Access Compliance Report Public Rights-of-Way (Curb Ramps)

Main Street: CERRITOS_AVE Cross Street: HEDLUND_DR Location: NW

ADA ID: RPRK210924113928 Ramp Type: Type 1 - Perpendicular Diagonal Initial Pass/Fail: Pass Overall Compliance: No Severity Score: 4

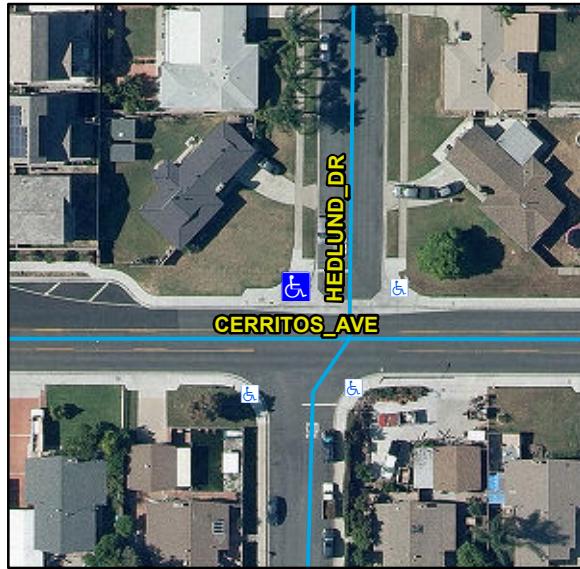
R304.2.2, R304.2.1, STD 1115

Remove & Replace Curb Ramp With Two New Directional Ramps or Equivalent.
